CHAPTER 10

Draft EIR Revisions

10.1 Draft EIR Text Revisions

Figure 2-18
Visitors Center [Revised]

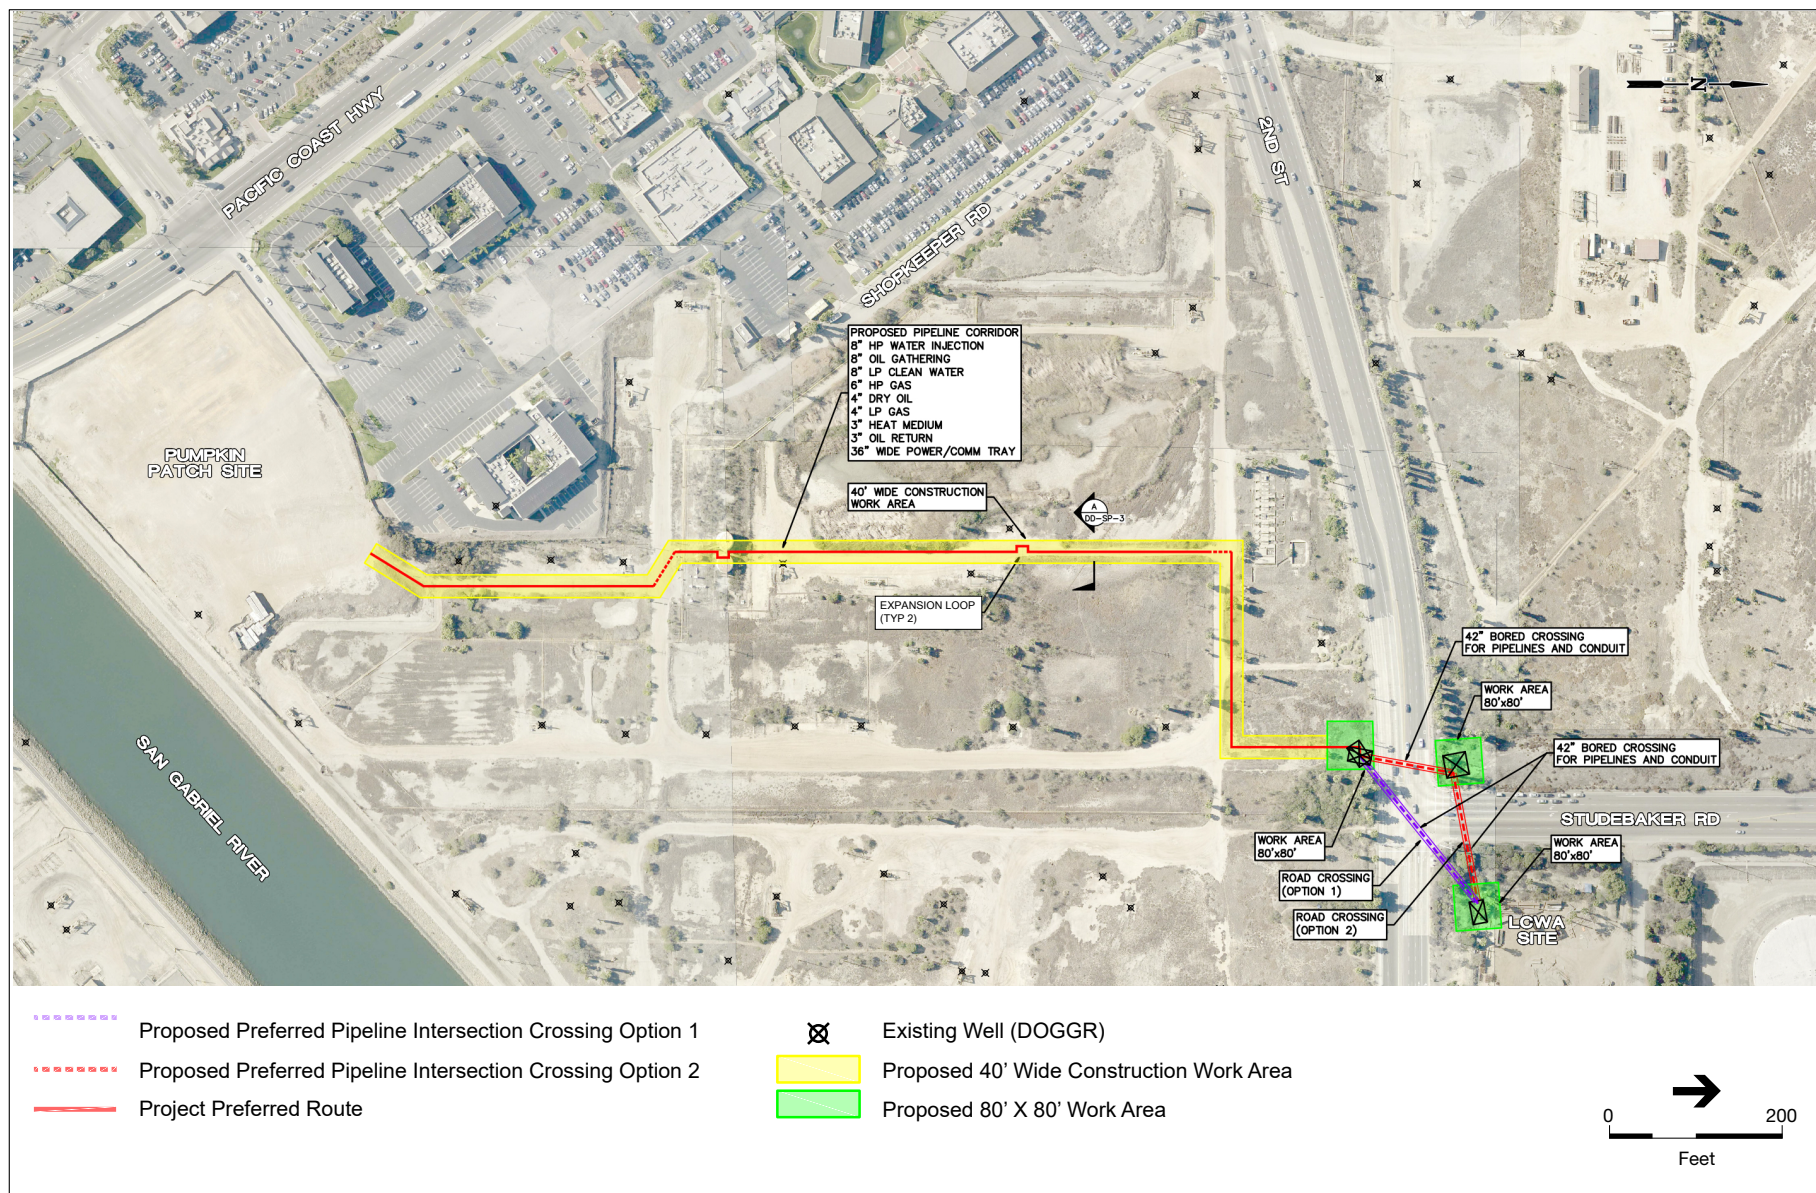
- **Figure 2-18, Visitors Center**, on Draft EIR p. 2-40, has been revised to show a more accurate depiction of this proposed project component, and the landscaping palette revised to focus on native vegetation. The green area that is in the artist's rendering is not intended to be turf but would be a mix of gravel (decomposed granite) and native vegetation when implemented.

Long Beach Cerritos Wetland . 150712
Figure 3.1-16
View 10: View from Pacific Coast Highway
Looking North toward the Pumpkin Patch Site (After) [Revised]

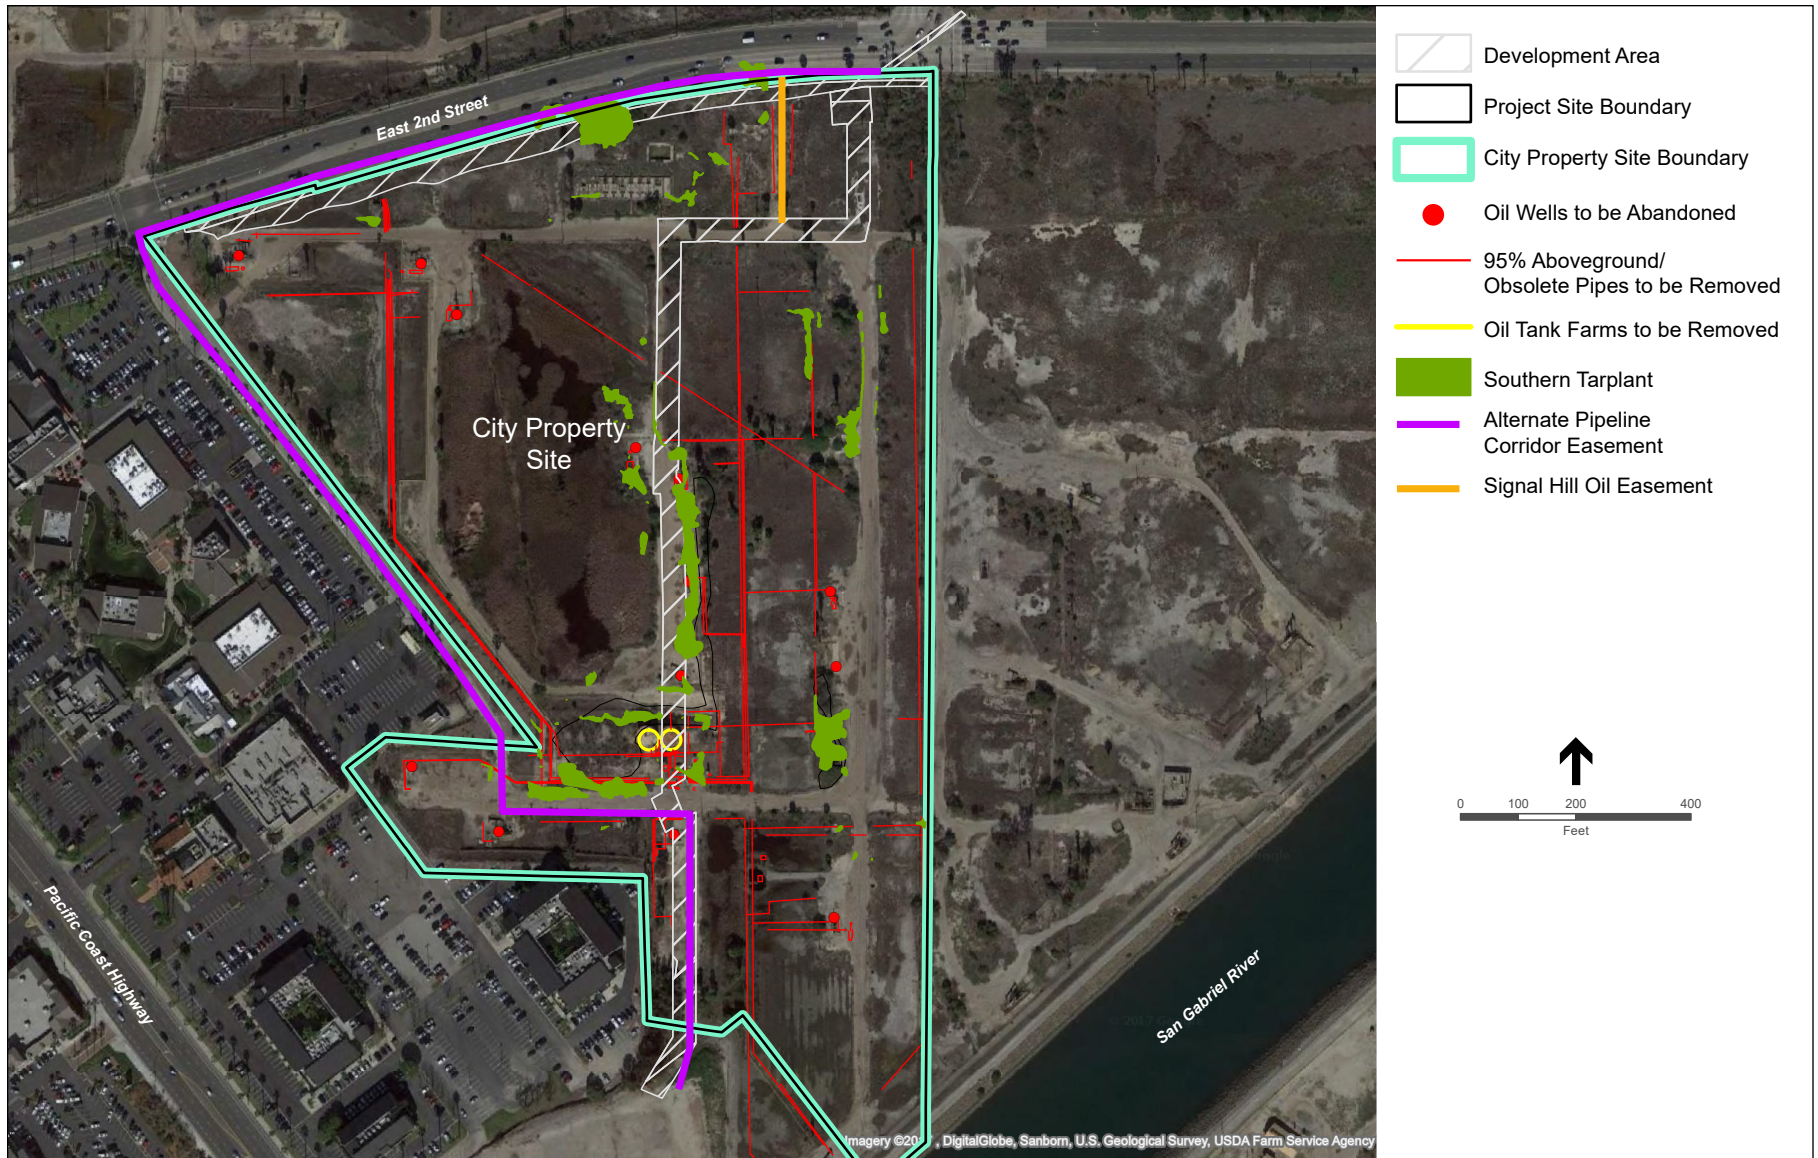
- **Figure 3.1-16, View 10: View from Pacific Coast Highway Looking North toward the Pumpkin Patch Site (After)**, on Draft EIR p. 3.1-24, has been revised to indicate the date for the "After" condition described in View 10.
